AMBASSADOR CONSTRUCTION CO., INC.

June 15, 1999

Re: Mayor's Office of Emergency Management
7 World Trade Center
Change Order #089
Amb. Job #S57-5175

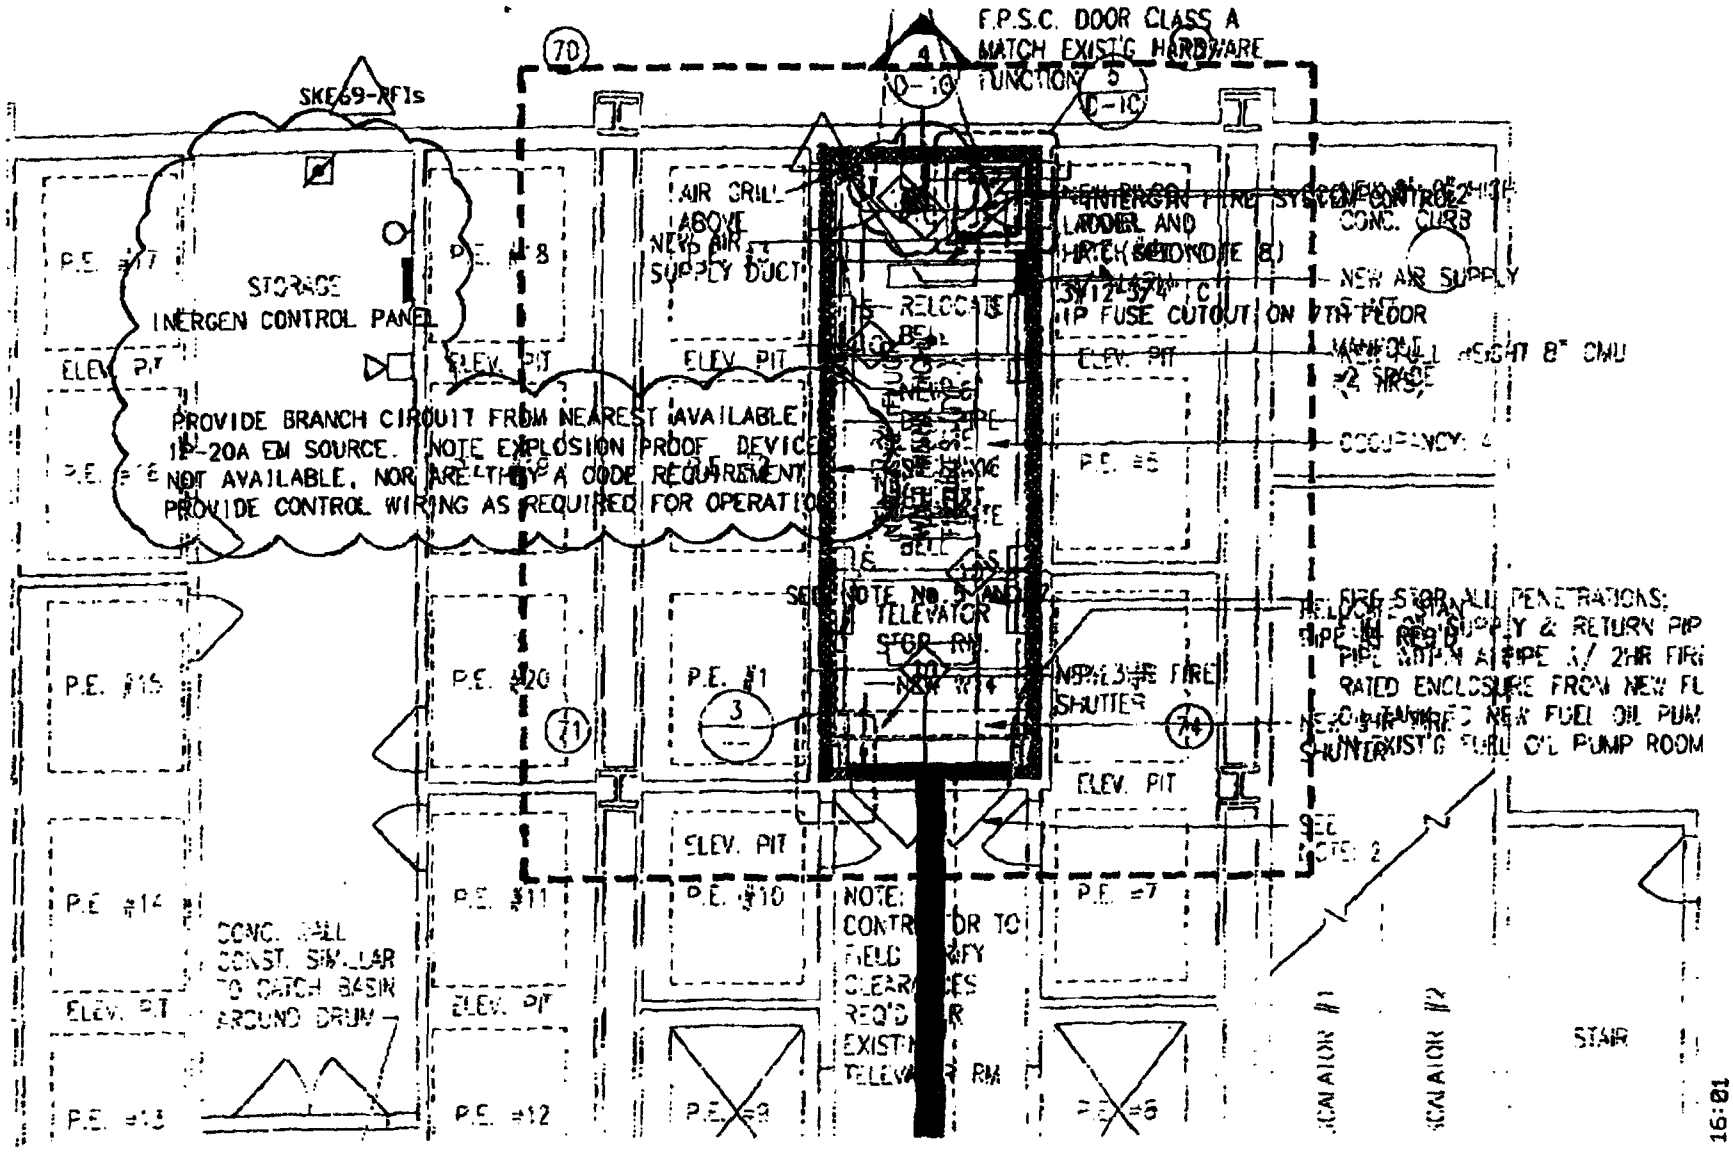
As per Swanke Hayden Connell Architects & Cosentini Associates sketch (attached 6/14/99) for the power and control wiring for the Inergen system in the fuel oil tank room.

Control wiring for control panel, strobe, two (2) thermo heaters, one (1) selonoid, pull stations. All in rigid conduit and fittings.

Please Note:
These items are not explosion-proof. All work on regular working hours.
